**CERTIFICATE OF APPROPRIATENESS**

**Property:** 820 Fannin Street, Lot 1 and 2, Tract 3A, 12A, 13, 13A, and 13B, Block 93, SSBB Subdivision. The property includes a historic 121,850 square foot 10-story glazed brick clad high-rise retail storefront with upstairs light industrial space situated on a 12,484 square foot (101' x 106') corner lot.

**Proposal:** Alteration – Alter the façade and install two canopies and signage.

WINDOW / DOOR SCHEDULE

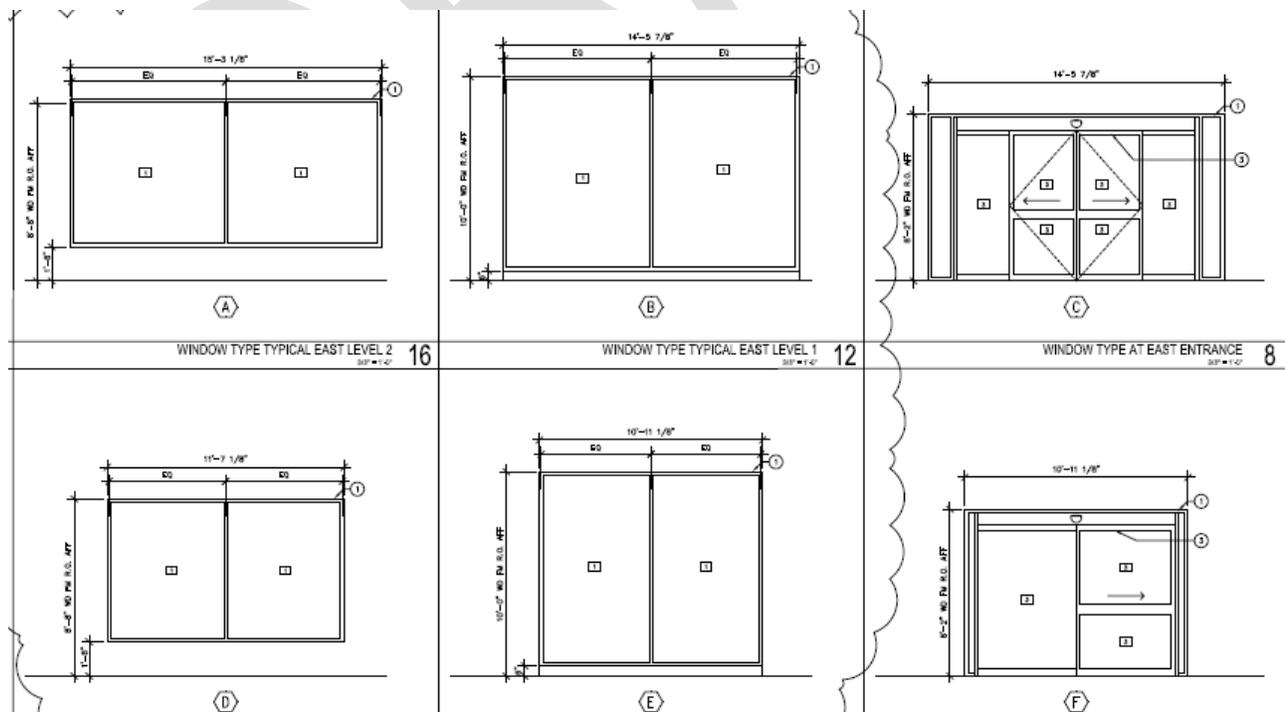
**Windows/Doors:** Each existing storefront bay features four non original single-lite aluminum framed storefront windows with single lite transoms on the first floor and four matching windows without transoms on the second. The applicant proposes to replace these windows with a pair of single-lite aluminum framed storefront windows with two lites separated by a single vertical divide.

### PROPOSED CANOPY WALKER STREET ELEVATION

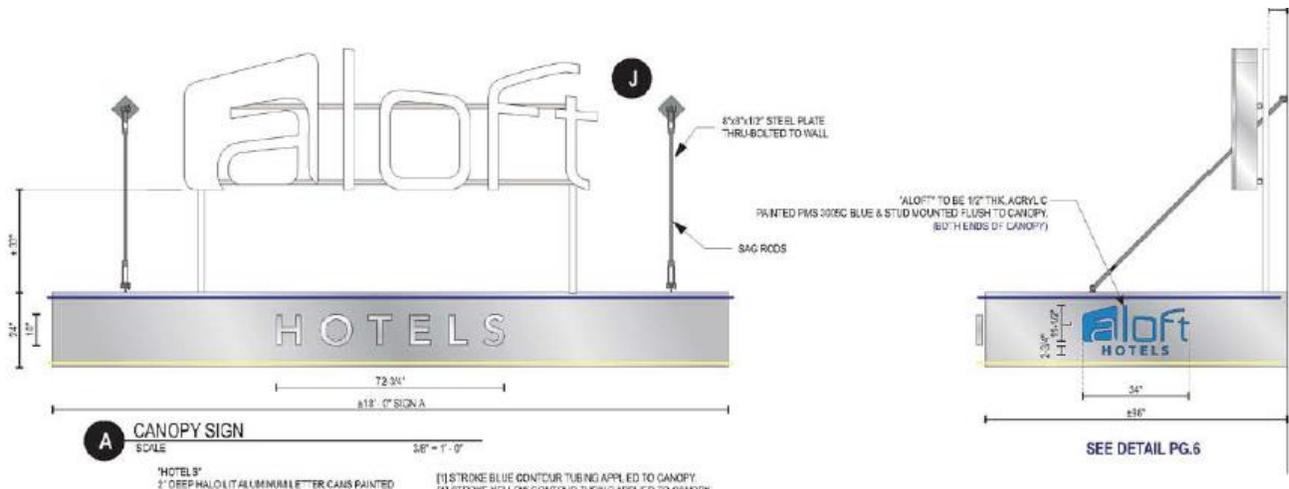
The applicant proposes to install two new canopies, one at the south and east elevations. These canopies will be made of metal and will be supported by two sag rods mounted into the façade of the structure. The canopies will also feature signage on their face and side reading “aloft” and “hotels.”

The south facing canopy will measure 18’ wide by 8’ deep. The east facing canopy will measure 21’ 10” wide by 12’ deep

**BLADE SIGN**

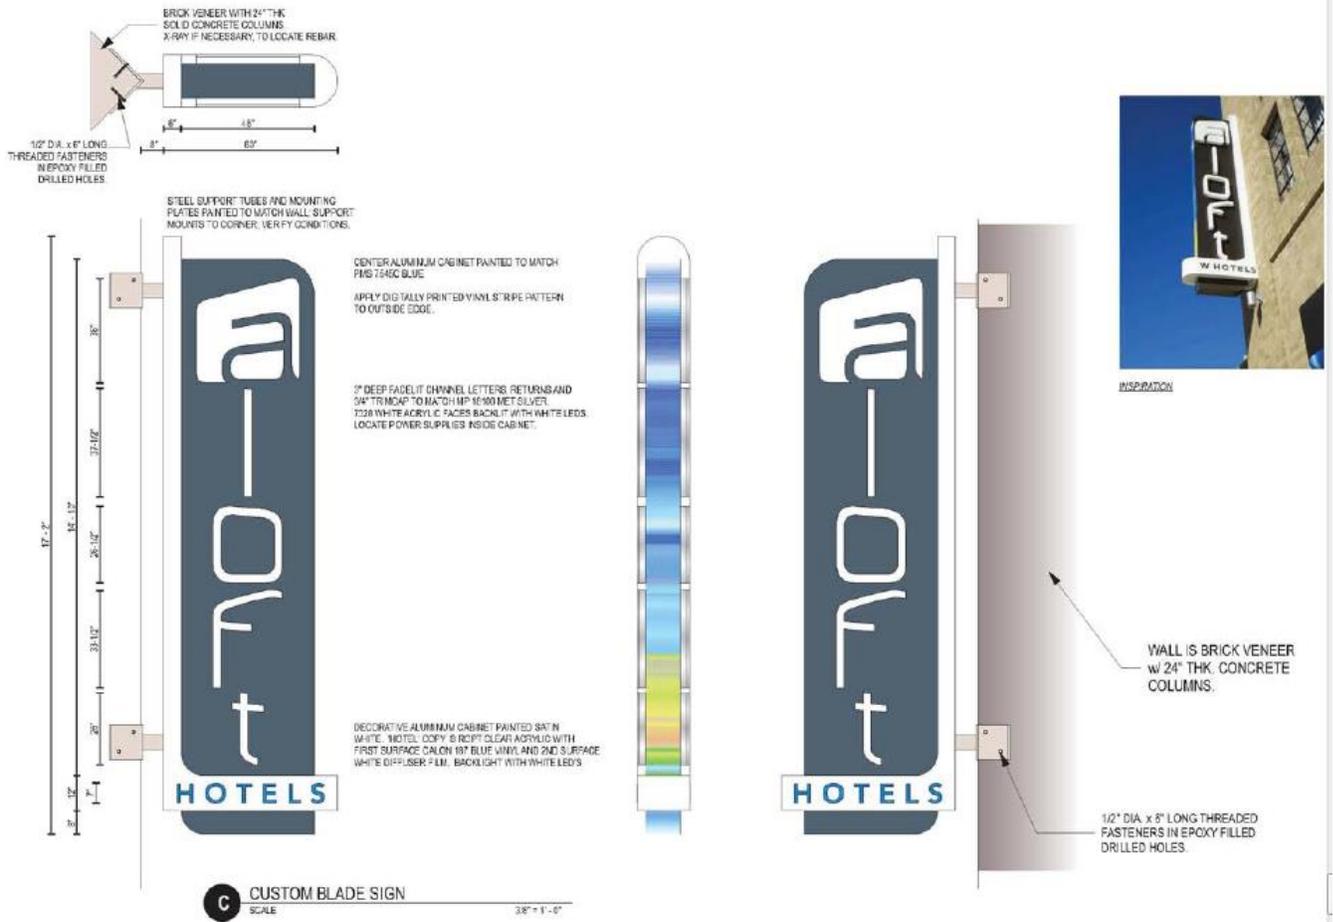
The aluminum clad blade sign will measure 17’ 2” tall by 5’ deep and will be mounted into the façade with eight ½” diameter by 6” deep metal fasteners. The sign will feature recessed channel letters spelling “aloft Hotels.” A sign of similar proportions was once mounted on the structure at this location, evident in historic photos provided by the applicant.
